Road Safety Audit Report

Incorporating
Stage 1/2 Completion of Detail Design;
Design Organisation Response to items raised.

Proposed Works to existing Public Footpaths through Meadow Gardens, North End Road Yapton

Client reference:
ITB14679

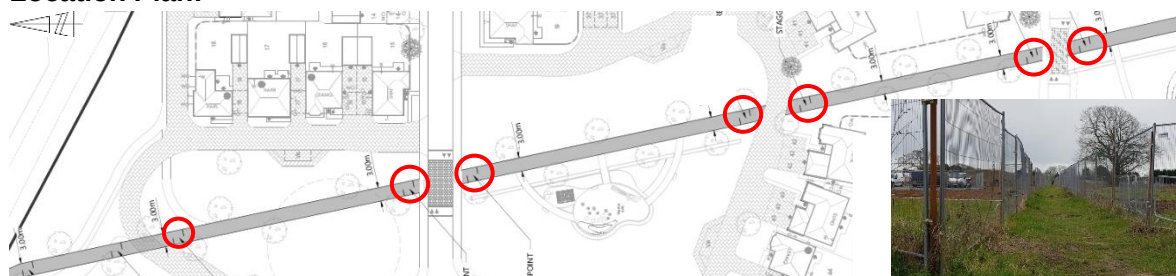
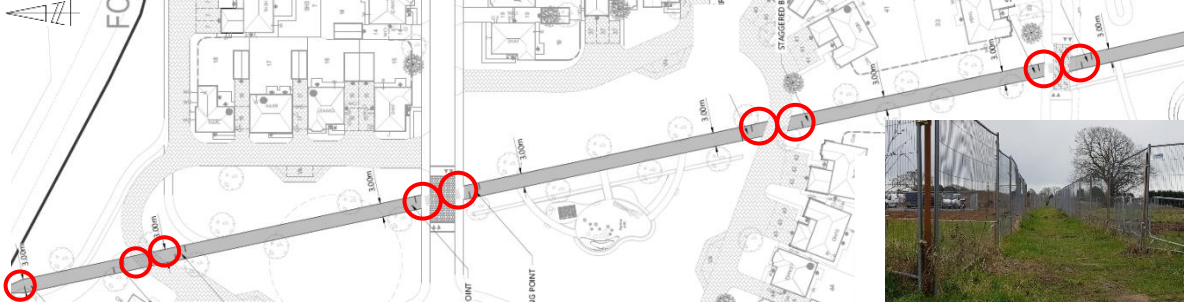
Location: Scheme

Summary: Users will travel around the proposed staggered barriers on uneven ground

Acc Type: User trip and fall

The existing footpath 357 that passes through a field to the east of North End Road and south of Ford Lane in an unmade and narrow route that is uneven in places. The proposals subject to this Stage 1/2 Road Safety Audit include the widening of the existing footpaths to 3 metres and the reconstruction with a 225mm base course below 75mm of dust and 100mm of limestone type 1 topped with 25mm of limestone dust which will provide an adequate surface that is cambered to ensure surface water drains to the soft verges either side that are detailed on the landscaping plans associated with the approved application Y/112/20/DOC. The current proposals illustrated on dwg ITB16479-GA-002 revision B included with the Audit Brief, identifies that staggered barriers are to be provided adjacent to all locations where the public right of way crosses the on-site roads. The scheme drawing also identifies that raised tables or shared surface areas are to be provided where the footpath crosses the on-site roads and the landscaping plans indicate that the crossings are to be fairly open with no high-level planting provided in close proximity. Whilst staggered barriers assist in slowing users to ensure that they proceed with caution, users tend to bypass the measures if a route is available. It is therefore likely that users of the public right of way, will bypass the staggered barriers on the adjacent soft verge which is likely to become uneven as a result of use particularly during inclement conditions. An uneven surface could give rise to trips, falls and personal injury.

DESIGN ORGANISATION RESPONSE provided by i-Transport on the 23 rd March 2021 following formal issue of this Stage 1/2 Road Safety Audit on the 22 nd March 2021	
Accepted – the staggered barriers have been removed from the internal aspect of the layout and replaced with bollards. The bollards are to be fitted with reflective material, and also incorporate way-finding for the Public Right of Way.	
B.3	JUNCTIONS
	<i>No Road Safety Concerns regarding JUNCTIONS have been raised at this stage</i>
B.4	WALKING CYCLING AND HORSE RIDING
B.4.1	PROBLEM
Location:	Scheme
Summary:	Users will travel around the proposed staggered barriers on uneven ground
Acc Type:	User trip and fall
The proposals that are subject of this Stage 1/2 Road Safety Audit include the provision of a surfaced 3 metre route for pedestrians through a proposed development between footpath 358 and Church Lane to the south and Ford Lane to the north as illustrated on dwg ITB16479-GA-002 revision B included with the Audit Brief. The proposed route is to cross the on-site roads that are to facilitate vehicular access, a number of times with two crossing of shared surface areas and two crossing of general carriageway where the crossing point is to be provided on a raised table. Each of the crossing locations is in-line where pedestrians walk towards the carriageway and are to consist of dropped kerbs that are understood to include an upstand of between 0 and 6mm and benefit from tactile paving. However, as illustrated on the scheme drawings, a minimum of two rows of tactile paving slabs are to be provided allowing for a minimum depth of 0.8 metres. Pedestrians could step across two rows of tactile paving and as such, visually pedestrians could enter the carriageway without warning. The crossing points are to be provided at shared surface areas or where raised tables are provided and as such, vehicles should be proceeding with caution at a low speed, however, a pedestrian entering the carriageway and the path of a vehicle without warning, could lead to vehicle pedestrian collisions. Furthermore, no tactile warning surface is provided adjacent to the stepped access to Ford Lane which could lead to pedestrians falling down the steps into the carriageway

Location Plan:

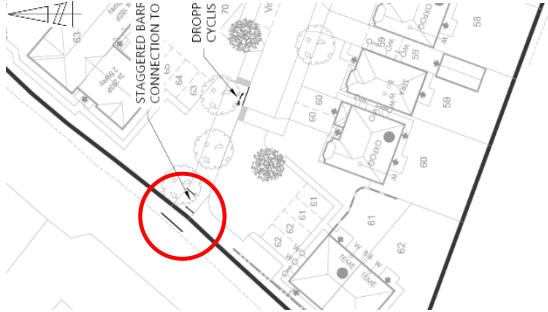
It is recommended that the staggered barriers are replaced with bollards that include reflective features to reduce the likelihood of users bypassing the surfaced route and crossing at a location away from the dropped kerb crossing points that benefit from tactile paving.
